Purpose of Change --base

Re: Application for a Permissive Change Filing with FCC ID: EW780-0348-00

The purpose of this document is to describe all the changes that are made on **Base Unit** to the new designed family models **VH6220 BS** from the original model **VH6210 BS** in order to meet the requirements.

VH6220 BS Mainboard layout

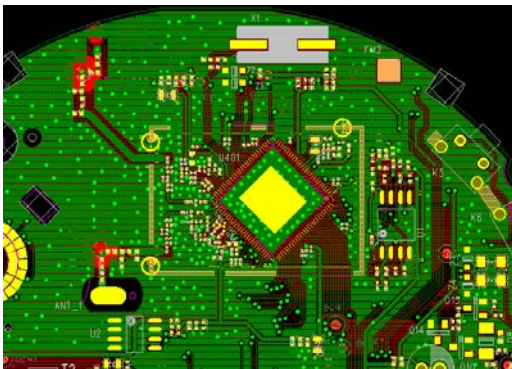
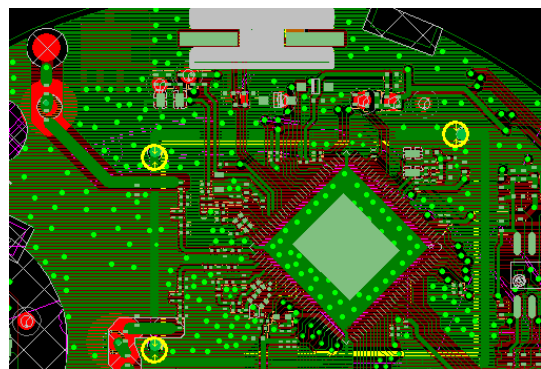
- **RF matching circuit and layout outside RF module**
- **Antenna and location**
 - Ant 0** - changed from “co-linear cable” to “co-axial wire+ metal plate” construction.
 - Location is changed from lower enclosure to upper enclosure.
 - Ant 1** - length is increased some and location is No Change
- **Non-RF circuit and layout**
- **External appearance**
